Preferred Project Report

Rainbow Beach Project Application MP 07_0001

Part 3A Project Application | St. Vincent's Foundation Pty. Ltd. | 9 May 2011

SVF RAINBOW BEACH DEVELOPMENT APPLICATIONS
MP 06_0085 "Rainbow Beach Concept Plan"
MP 07_0001 "Project Application - Open Space Corridor and
Constructed Wetland, Rainbow Beach"
RESPONSE TO SUBMISSIONS

FIGURE 8
OPEN SPACE CORRIDOR PLAN - PROPOSED DEVELOPMENT WATER FEATURES - EAST

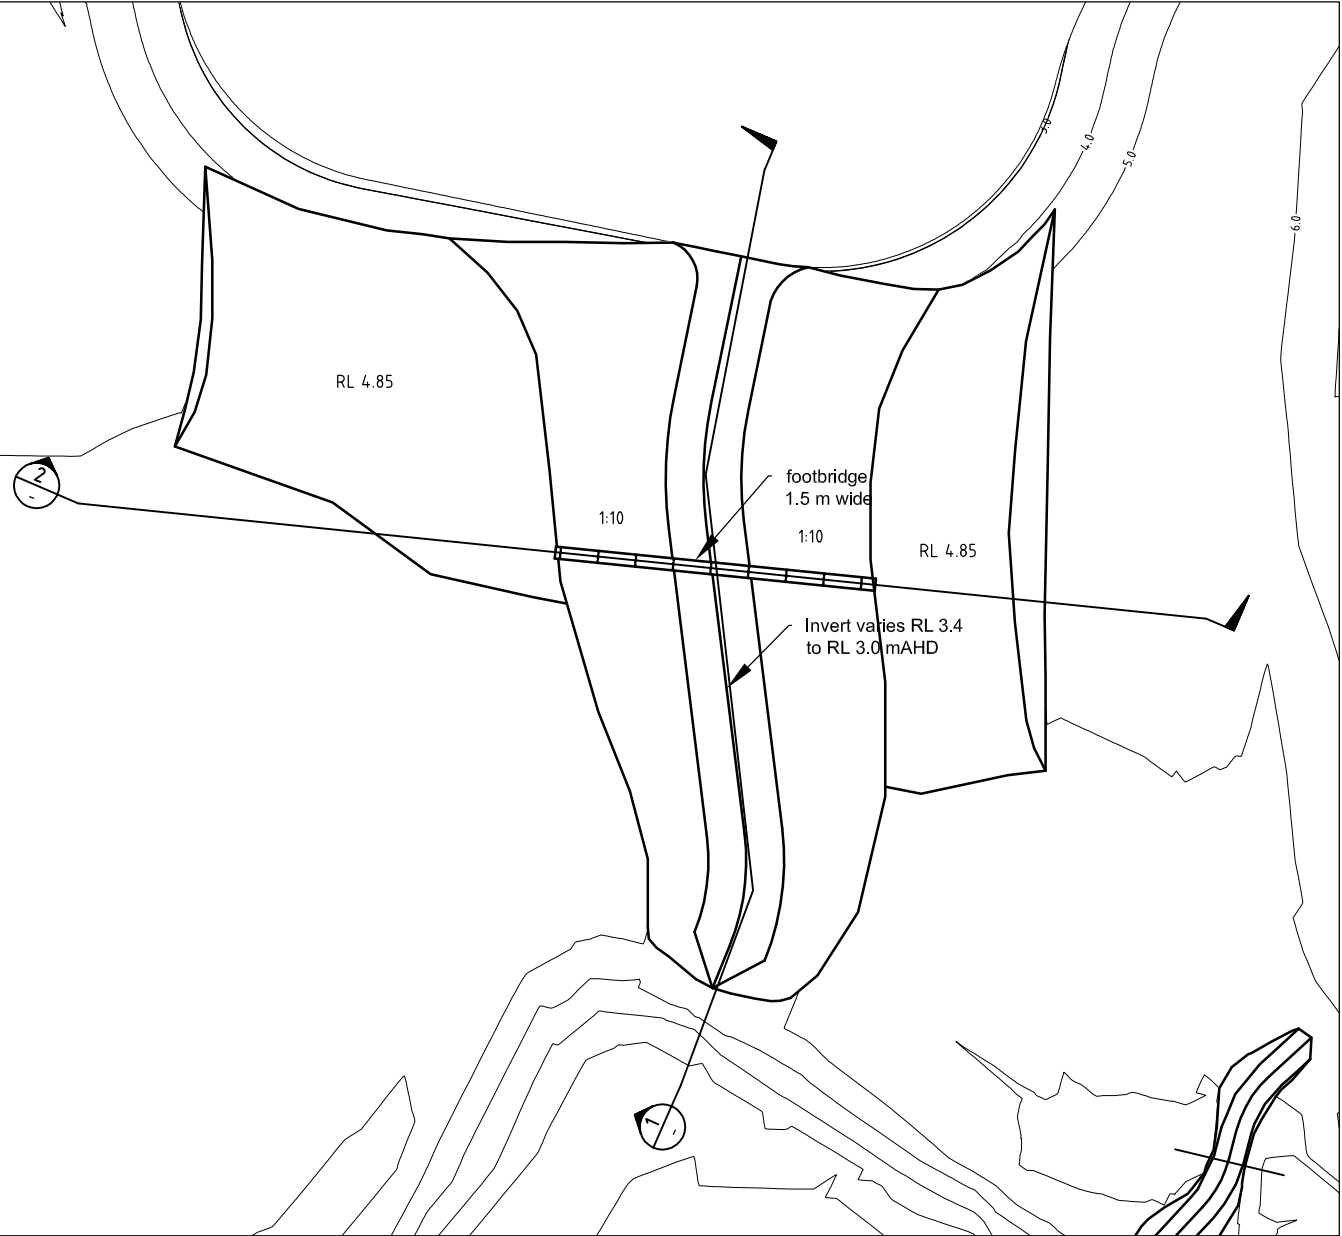
Item 20. The treatment wetlands W1A to W1E all receive runoff from various separate parts of the new development and discharge into the larger Constructed Wetlands W1 ("lake"). The attached revised Figures 7 & 8 make this clear.

Item 21. The attached revised Figures 7 & 8 correct and clarify the previous inconsistencies. The attached revised Figure 23 also shows the proposed drainage network with these updates.

Item 23. The attached revised Figures 7 & 8 show the final proposed contours.

Scale NTS (A3)
FIGURE 24
DRAINAGE HYDRAULIC GRADIENTS

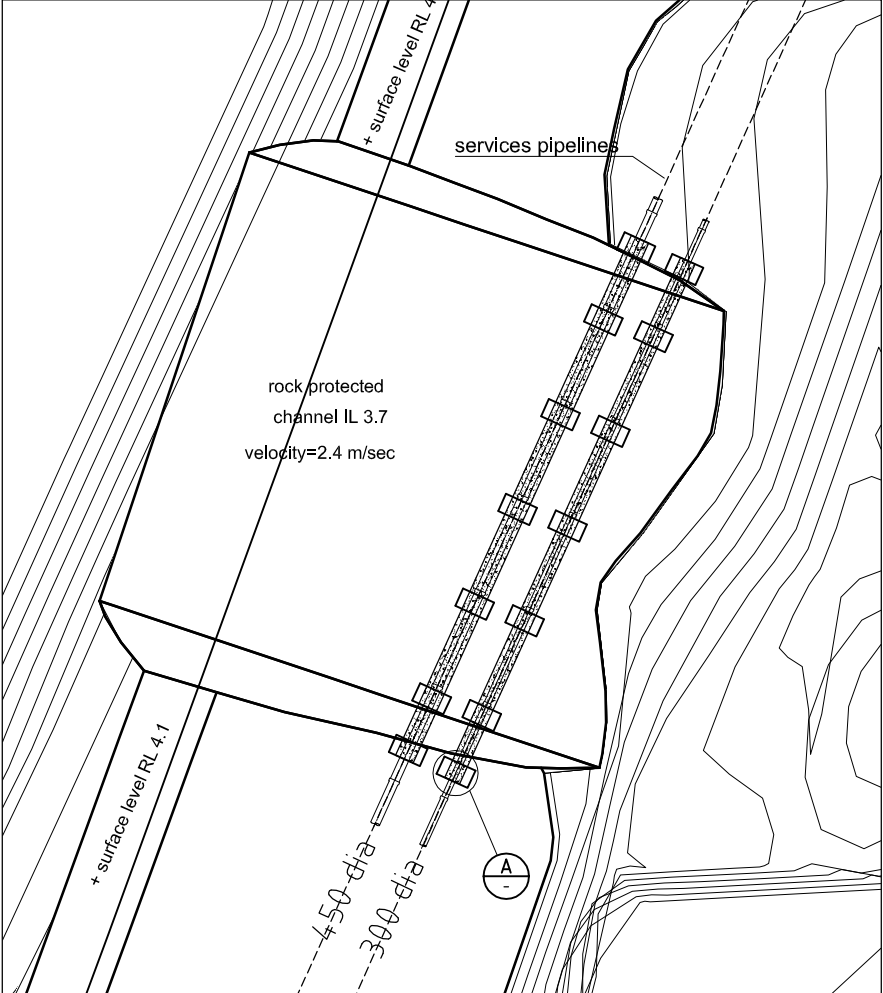
Item 19. There was an error in the water level of wetland W3 previously shown in Figure 24. It should be RL 4.3. A corrected revised Figure 24 (dated 9-12-2010) is attached.

FIGURE 28
CONSTRUCTED WETLANDS OUTLET CONTROL STRUCTURE S5 PLAN

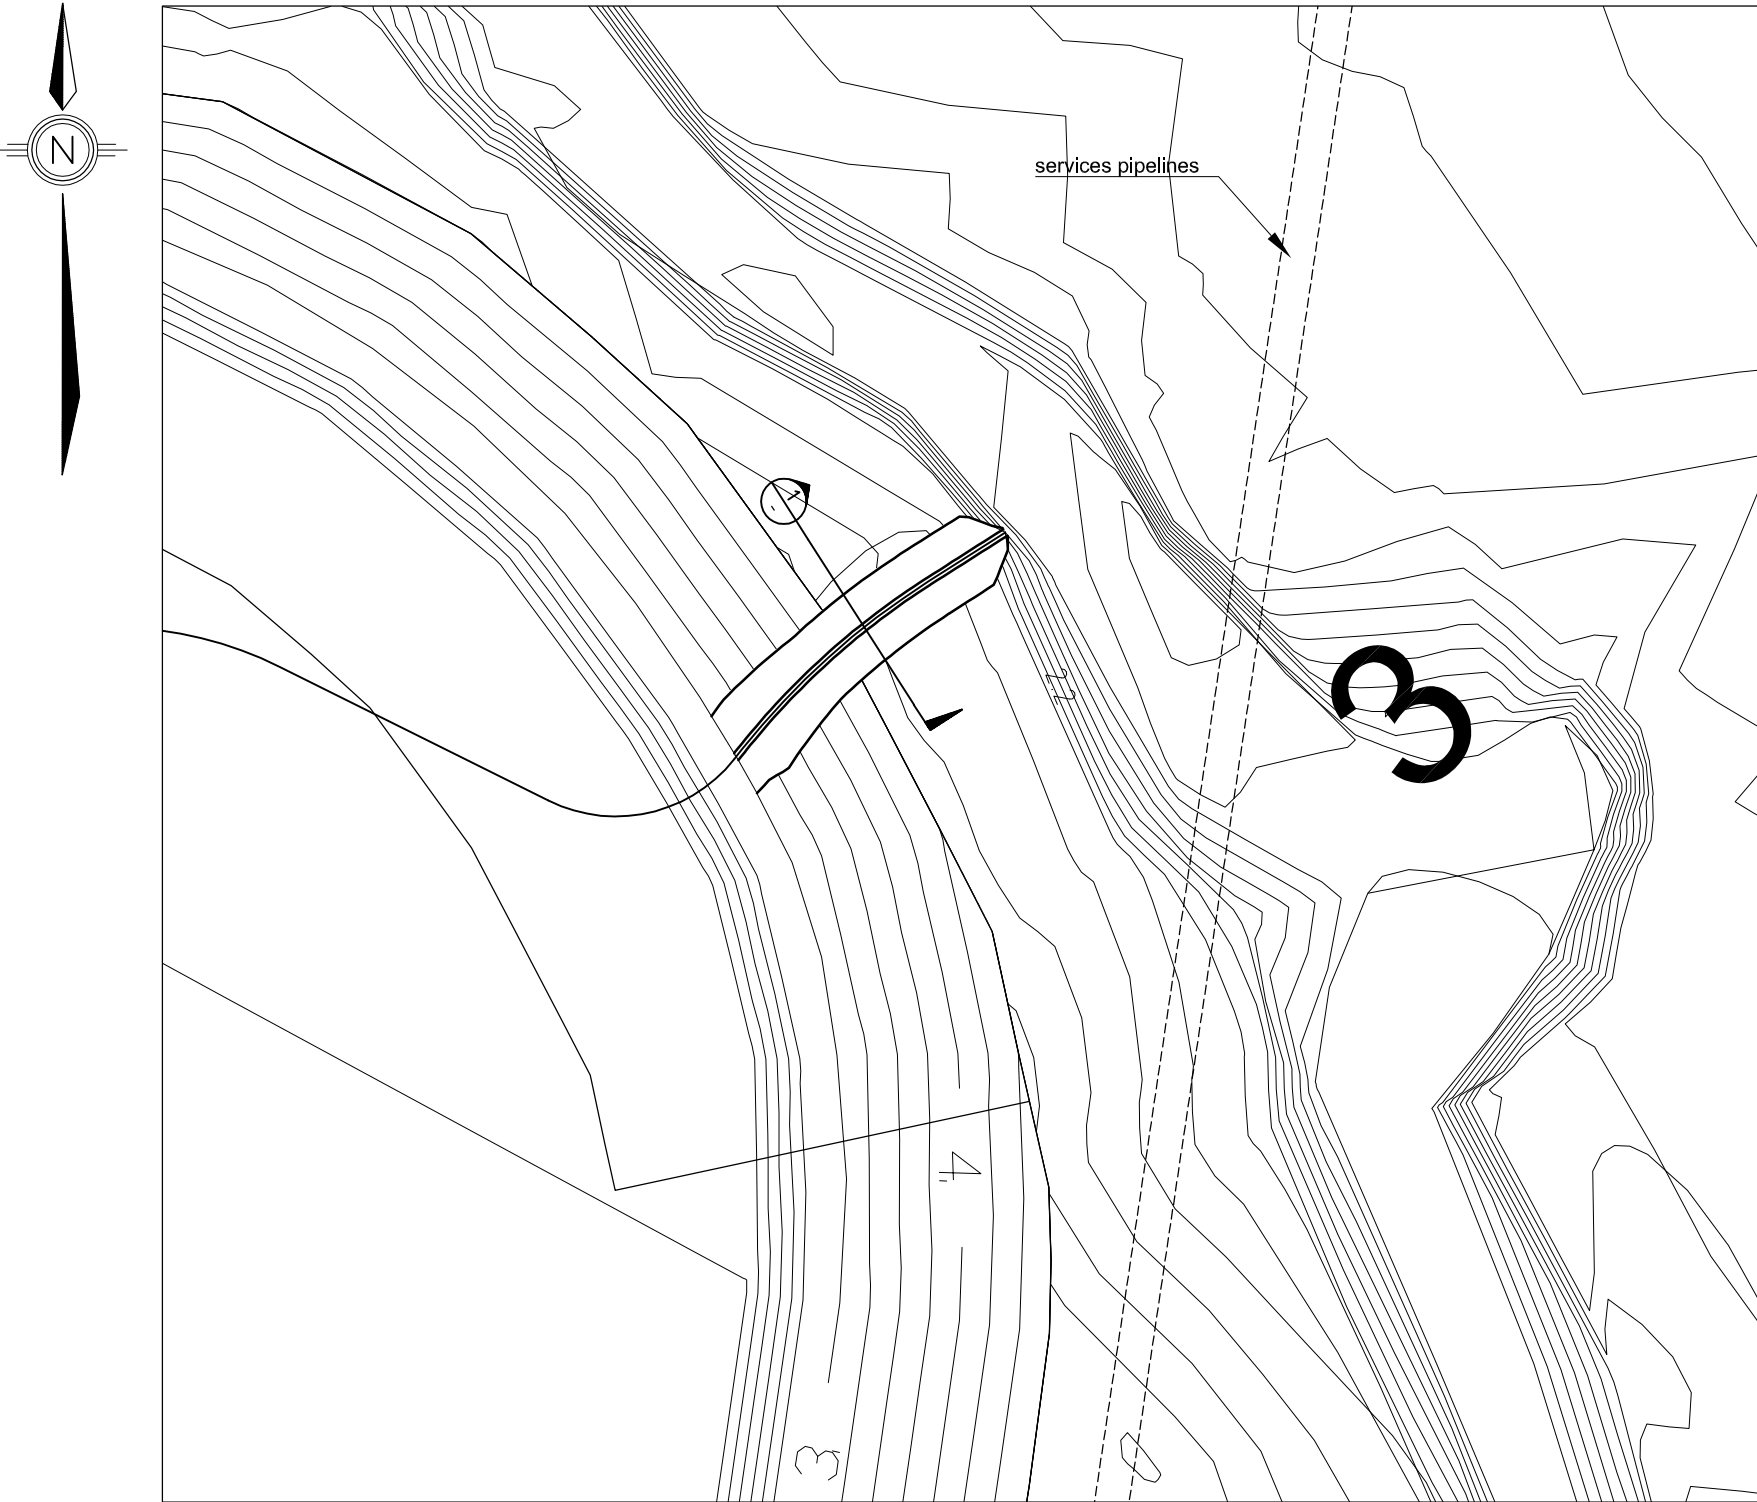
Item 29. Figures 28, 30, 31 and 33 had some printing errors which have now been corrected. Revised Figures are attached.
